# **Planning Commission**

Wednesday, January 7, 2026

# TECHNICAL REVIEW PLAT REQUIREMENTS REGULAR PLANNING COMMISSION MEETING January 7, 2026

PLAT OF STRIPES CORPUS CHRISTI

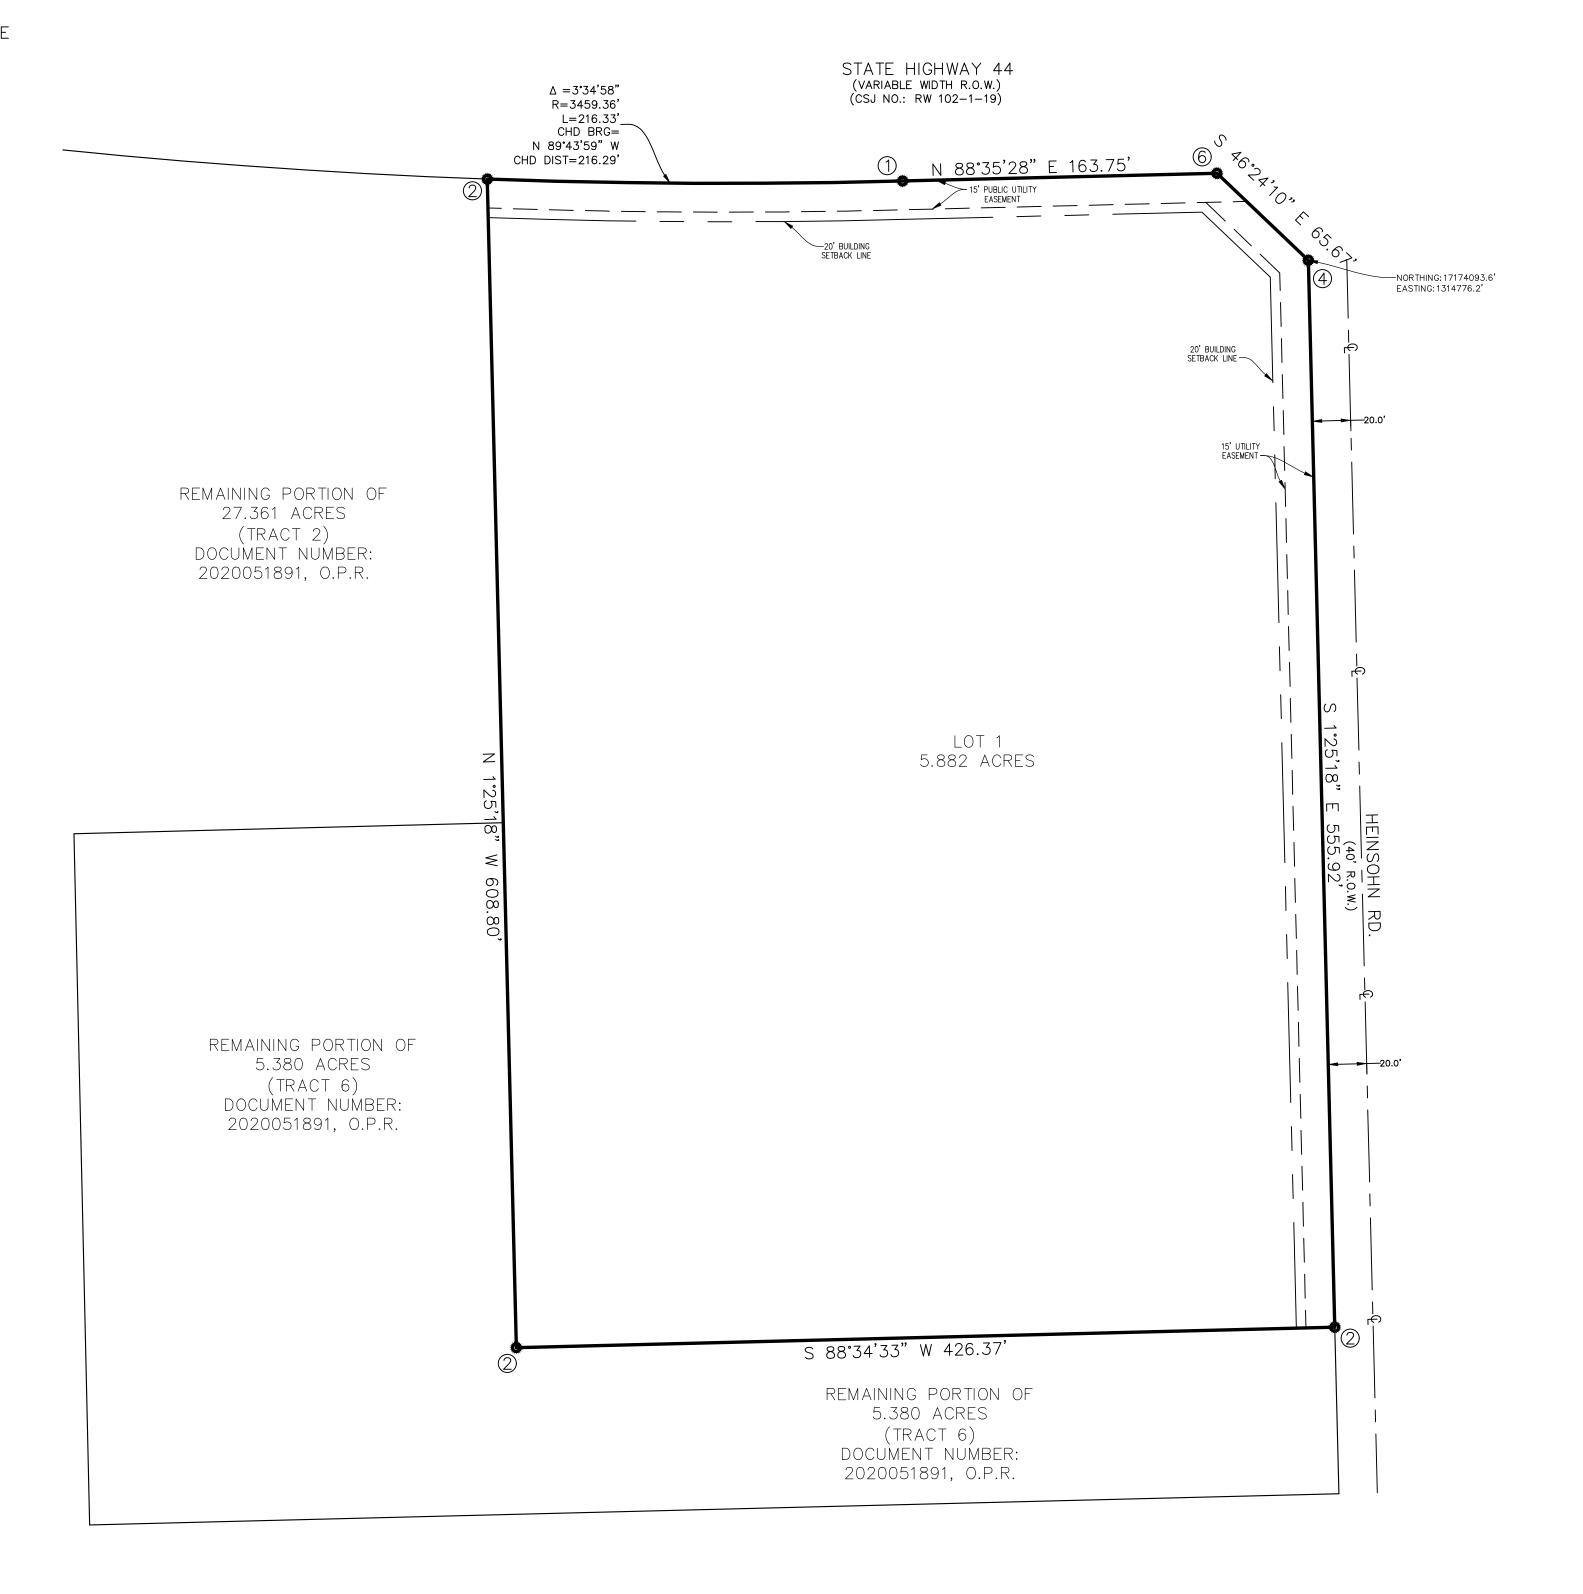
Comment ID	Author : Department	Status	Review Comments	Applicant Response Comments
23	Alex Harmon : DS	Closed	Improvements Required for Recordation, per UDC 8.1.4. A. Streets: No Sidewalks: Yes B. Water: Yes Fire hydrants: Yes C. Wastewater: Yes D. Stormwater: No E. Public open space: No F. Permanent monument markers: No Please note, improvements required should be constructed to city standards, found in Article 8 and the IDM.

Comment ID	Page Reference	Annotation Type	Author : Department	Status	Review Comments	Applicant Response Comments
1	P001	Note	Mina Trinidad : DS	Closed	Please resubmit necessary documents within 10 business days per UDC 3.1.6.e: "The notification shall list all missing or incomplete items and provide at least ten business days for the applicant to resubmit the material. The applicant may request an additional meeting for explanation of the missing or incomplete items. If the application is not resubmitted within the period specified, the application shall be deemed rejected and shall not be accepted for filing. After an application has been rejected, a new application and fee shall be required."	
2	P001	Note	Mina Trinidad : DS	Closed	Application for Land Subdivision Form required to be submitted.  On the Application, if you are to select "30-day plat review" please keep in mind that once the Technical Review Committee (TRC) comments are sent back to you, you will have the option to request additional review time (if needed). If you do not request additional review time, your application will be sent to Planning Commission with open comments from TRC.

3	P001	Note	Mina Trinidad : DS	Closed	Storm Water Quality Management Plan (SWQMP) required to be submitted.	
4	P001	Note	Mina Trinidad : DS	Closed	There appears to be a discrepancy between the property listed in the deed and referenced on the plat of "Lots 17 and 21."  Please provide appropriate deed for properties being platted.

Comment ID	Page Reference	Annotation Type	Author : Department	Status	Review Comments	Applicant Response Comments
5	P001	Note	Mina Trinidad : DS	Closed	Per emails, the applicant has requested the 30-day review tract. Please keep in mind that once the Technical Review Committee (TRC) comments are sent back to you, you will have the option to request additional review time (if needed). If you do not request additional review time, your application will be sent to Planning Commission with open comments from TRC.	
7	P001	Note	Mina Trinidad : DS	Closed	Per Bria, coordinate with CCW about 2 manholes on property.	
8	P001	Note	Mina Trinidad : DS	Closed	11/18/2025 Update: Increase text size for better visibility.  Move plat heading to the top of the center of page.	
9	P001	Note	Mina Trinidad : DS	Closed	(Informational) Traffic/ROW: Proposed Driveway access to public City Street shall conform to access management standards outlined in Article 7 of the UDC (UDC 7.1.7) The developer / applicant can reach out to rowmanagement@cctexas.com for further assistance regarding the ROW Construction Permit they will be required to submit prior to any temporary and / or permanent driveway off the immediate roadways. The ROW Construction permit must be submitted and approved prior to any form of construction within City ROW. Any contractor working within City ROW without an approved ROW Construction Permit can be held in non-compliance and can be subject to a fee of \$1,500 per day of unpermitted work, as per City of Corpus Christi Municipal Code 49-112 (9). Proposed driveway access to a public maintained by the Texas Department of Transportation (TXDOT) shall conform to TXDOT criteria. The developer and/or agent is responsible for coordination with the local TXDOT Area Office. The PW-Traffic Department (Right-of-Way Division) is responsible for reviewing and permitting new construction and repairs/modifications to driveways, sidewalks, curb, and gutter. The review and approval of the permit must be approved prior to the issuance of the building permit (issued by DSD). (Refer to Municode Chapter 49-30 for permit requirements.) Public improvement plans shall include all signage and pavement markings needed for traffic operations (e.g. signage, striping, traffic mitigation

Comment ID	Page Reference	Annotation Type	Author : Department	Status	Review Comments	Applicant Response Comments
					devices) in addition to standard "regulatory" STOP and street name blade sign installations. Additionally, cul-de-sacs must include either "NO OUTLET" or "DEAD END" signage. Temporary Dead-Ends should include the appropriate object markers and one-way streets must include signage for any one-way designations and affected side streets. Reference: Texas MUTCD based on CC UDC Article 8.1.3.A Pavement markings shall be installed within the scope of the subdivision in accordance to specifications of, and subject to, latest version of the "Texas Manual on Uniform Traffic Control Devices (TMUTCD), public improvement plan reviews and inspections, by the City. Reference: Texas MUTCD and UDC Article 8.1.3.A Pavement markings shall be installed within the scope of the subdivision on all streets classified as a collector (C1) or higher on the City's Urban Transportation Plan Map. Streets not designated as a collector (C1) or higher but constructed with a 40-foot width (back-of-curb to back-of-curb) will be subject to specifications stated in public improvement plan review. Reference: Texas MUTCD based on CC UDC Article 8.1.3.A

10	P001	Note	Mina Trinidad : DS	Closed	Remove signature blocks as Plat is a Preliminary Plat. Preliminary plats go to Planning Commission but do not get recorded, therefore, signature blocks are not necessary.	
11	P001	Note	Mina Trinidad : DS	Closed	(Informational) Traffic/ROW: The developer / applicant can reach out to ROWManagement@cctexas.com for further assistance regarding ROW Permit Questions. Any contractor working within City ROW without an approved ROW Construction Permit can be held in non-compliance and can be subject to a fee of \$1,500 per day of unpermitted work, as per City of Corpus Christi Municipal Code 49-112 (9). For further information, please email ROWManagement@cctexas.com. A contractor can be found in non-compliance while working on city ROW with a permit if they deviate from the proposed work and permit approved by ROW. A fee of \$1,500.00 per day as per City of Corpus Christi Municipal Code 49-112 (9) & Code Sec. 49 – 57- 1 (h) & Code Sec. 49 – 57 – 2. For further information, please email ROWManagement@cctexas.com. A person / contractor / applicant shall be held responsible for damage to and in public

12	P001	Note	Mina Trinidad : DS	Closed	(Informational) Traffic/ROW: All traffic signs shall be furnished and installed by the Developer in accordance to specifications of, and subject to, latest version of the "Texas Manual on Uniform Traffic Control Devices (TMUTCD), public improvement plan reviews and inspections, by the City. This includes furnishing and installing "STOP" signs. Reference: Texas MUTCD based on CC UDC Article 8.1.3.A. All entries to private streets from public streets shall be clearly signed by the owners or homeowners' association as a "private street." (Reference UDC Article 8.2.1.J. Private Streets) The developer or their representative is required to submit a "Street Lighting Plan", indicating the proposed locations and fixture type of streetlights, for review and approval to the City's Traffic Engineering Department. All new fixture types will be LED. Streetlights shall meet design requirements per the City of Corpus Christi Infrastructure Design Manual (IDM) Chapter 8 - Street Lighting Design Policy and Guidelines. The "Street Lighting Plan" shall indicate all existing streetlights within 500-ft (+/-) of proposed streetlights along tangent street sections. Preliminary "written" approval of the "Street Lighting Plan", by the City's Traffic Engineering Department, is required before the utility company (AEP or NEC) can start the design of the street lighting system and determine developer fees, which are required for plat recordation. Traffic

18	P001	Note	Mina Trinidad : DS	Closed	Remove signature blocks as Plat is a Preliminary Plat. Preliminary plats go to Planning Commission but do not get recorded, therefore, signature blocks are not necessary.	
19	P001	Note	Mina Trinidad : DS	Closed	11/18/2025 Update: Increase text size for better visibility. General note needs to follow City of Corpus Plat Guidelines for the "Receiving Waters" general note.	
					Add the Storm Water Receiving Waters general note on the plat.	
20	P001	Note	Mina Trinidad : DS	Closed	11/18/2025 Update: Increase text size for better visibility.	
					On side of plat ensure owners name, engineer's information, and surveyor's information is provided.	
22	P001	Callout	Alex Harmon : DS	Closed	Place a 15' UE along Heinsohn Rd per UDC 8.2.3.A.	
32	P001	Note	Mina Trinidad : DS	Closed	(Informational) CCRTA: This plat is not located along any existing or foreseeably planned CCRTA service route.

Comment ID	Page Reference	Annotation Type	Author : Department	Status	Review Comments	Applicant Response Comments
24	U004	Note	Alex Harmon : DS	Closed	11/3/25 UPDATE:  Comment response indicates it is on the Utility Plan - What sheet of utility plan shows the demands?  Include estimated water and wastewater usage on utility plan to ensure the proposed development is in compliance with the Comprehensive Plan, implementation plan and applicable Utility Master Plan and the availability and capacity of public improvements needed to support the development.	
26	U004	Note	Alex Harmon : DS	Closed	11/3/25 UPDATE: To be addressed on Pls.  Per UDC 8.1.5., All required improvements shall be designed and installed in order to provide for a system of utilities, storm water and streets and to create continuity of improvements among adjacent properties.	
30	U004	Note	Mina Trinidad : DS	Closed	(Informational as item will be required at Final Plat) CCW:  1. Water construction is required for platting (UDC 1.2.1.D & 8.2.6; Water Distribution Standards). CCW will review Public Improvements.  2. Wastewater construction is required for platting (UDC 1.2.1.D & 8.2.7; Wastewater Collection System Standards). CCW will review wastewater as public improvements.

31	U004	Note	Mina Trinidad : DS	Closed	12/18/2025 Update: (Edgar Diaz Ruiz) No additional comments at this time.  11/18/2025 Update: Comment not addressed.  CCW (Mikail Williams): Please provide water and wastewater demands.	
33	U004	Note	Mina Trinidad : DS	Closed	(Informational) Fire: Comments 10-18 10. Note: An accessible road and a suitable water supply is required once construction materials are brought on site. 11. 503.2.1 Dimensions. Fire apparatus access roads shall have an unobstructed width of not less than 20 feet, exclusive of shoulders and an unobstructed vertical clearance of not less than 13 feet 6 inches. 12. D103.1 Access road width with a hydrant. Where a fire hydrant is located on a fire apparatus

Comment ID	Page Reference	Annotation Type	Author : Department	Status	Review Comments	Applicant Response Comments
					access road, the minimum road width shall be 26 feet, exclusive of shoulders.  13. The minimum required width of 20 feet that shall be maintained means a clear unobstructed path that allows the passage of fire apparatus. Where Fire Apparatus Access is constructed to the minimum of 20 feet, no parking is allowed within the fire apparatus lane. Where a fire hydrant is located on the street, the minimum unobstructed clearance shall be 26 feet. In this instance, no parking is allowed on one side of the street.  The minimum UDC residential street width is 28 ft. curb to curb. Any parking along the street that reduces the width to less than 20 ft. is prohibited and the Fire Code Official and will require painting "NO PARKING-FIRE LANE" along one side of the street.  14. Note: Calculated Turning Radii for Fire Apparatus: Inside Turn: 20 ft. 3 in. Curb to curb: 36 ft. 8 in. Wall to wall: 44 ft. 8 in. Note: The turning radius for fire apparatus should not be less than 45 degrees and curb to curb 36 feet. As a result, developers should be particuarly careful not to design streeets with acute angles that would prevent fire apparatus from completing a turn without having to back up to negotiate the turn.  15. 503.4 Obstruction of fire apparatus access roads. Fire apparatus access roads shall not be obstructed in any manner, including the parking of vehicles. The minimum widths and clearances established in sections D103 shall always be maintained.  16. 503.3 Marking: Where required by the fire code official, approved signs, or other approved notices the include the words NO PARKING-FIRE LANE shall be provided for fire apparatus access roads to identify such roads to prohibit the obstruction thereof. The designation of a fire lane can be marked with conspicuous signs which have the words:" Fire Lane-No Parking" at 50-foot intervals. In lieu of signs, fire lanes may be marked along curbing with the wording, "Fire Lane-No Parking" at 15-foot intervals.

Comment ID	Page Reference	Annotation Type	Author : Department	Status	Review Comments	Applicant Response Comments
					official, approved signs, or other approved notices the include the words NO PARKING-FIRE LANE shallbe provided for fire apparatus access roads to identify such roads to prohibit the obstruction thereof. The designation of a fire lane can be marked with conspicuous signs which have the words:" Fire Lane-No Parking" at 50-foot intervals. In lieu of signs, fire lanes may be marked along curbing with the wording, "Fire Lane-No Parking" at 15-foot intervals.  18. Commercial development of the property will require further Development Services review.	
34	U004	Note	Mina Trinidad : DS	Closed	(Informational) Fire: Comments 10-18  10. Note: An accessible road and a suitable water supply is required once construction materials are brought on site.  11. 503.2.1 Dimensions. Fire apparatus access roads shall have an unobstructed width of not less than 20 feet, exclusive of shoulders and an unobstructed vertical clearance of not less than 13 feet 6 inches.  12. D103.1 Access road width with a hydrant. Where a fire hydrant is located on a fire apparatus access road, the minimum road width shall be 26 feet, exclusive of shoulders.  13. The minimum required width of 20 feet that shall be maintained means a clear unobstructed path that allows the passage of fire apparatus. Where Fire Apparatus Access is constructed to the minimum of 20 feet, no parking is allowed within the fire apparatus lane.  Where a fire hydrant is located on the street, the minimum unobstructed clearance shall be 26 feet. In this instance, no parking is allowed on one side of the street.  The minimum UDC residential street width is 28 ft. curb to curb. Any parking along the street that reduces the width to less than 20 ft. is prohibited and the Fire Code Official and will require painting "NO PARKING-FIRE LANE" along one side of the street.  14. Note: Calculated Turning Radii for Fire Apparatus: Inside Turn: 20 ft. 3 in.  Curb to curb: 36 ft. 8 in.  Wall to wall: 44 ft. 8 in.

Comment ID	Page Reference	Annotation Type	Author : Department	Status	Review Comments	Applicant Response Comments
					Note: The turning radius for fire apparatus should not be less than 45 degrees and curb to curb 36 feet. As a result, developers should be particuarly careful not to design streeets with acute angles that would prevent fire apparatus from completing a turn without having to back up to negotiate the turn.  15. 503.4 Obstruction of fire apparatus access roads. Fire apparatus access roads shall not be obstructed in any manner, including the parking of vehicles. The minimum widths and clearances established in sections D103 shall always be maintained.  16. 503.3 Marking: Where required by the fire code official, approved signs, or other approved notices the include the words NO PARKING-FIRE LANE shall be provided for fire apparatus access roads to identify such roads to prohibit the obstruction thereof. The designation of a fire lane can be marked with conspicuous signs which have the words:" Fire Lane-No Parking" at 50-foot intervals. In lieu of signs, fire lanes may be marked along curbing with the wording, "Fire Lane-No Parking" at 15-foot intervals.  17. 503.3 Marking: Where required by the fire code official, approved signs, or other approved notices the include the words NO PARKING-FIRE LANE shall be provided for fire apparatus access roads to identify such roads to prohibit the obstruction thereof. The designation of a fire lane can be marked with conspicuous signs which have the words:" Fire Lane-No Parking" at 50-foot intervals. In lieu of signs, fire lanes may be marked along curbing with the wording, "Fire Lane-No Parking" at 15-foot intervals.  18. Commercial development of the property will require further Development Services review.
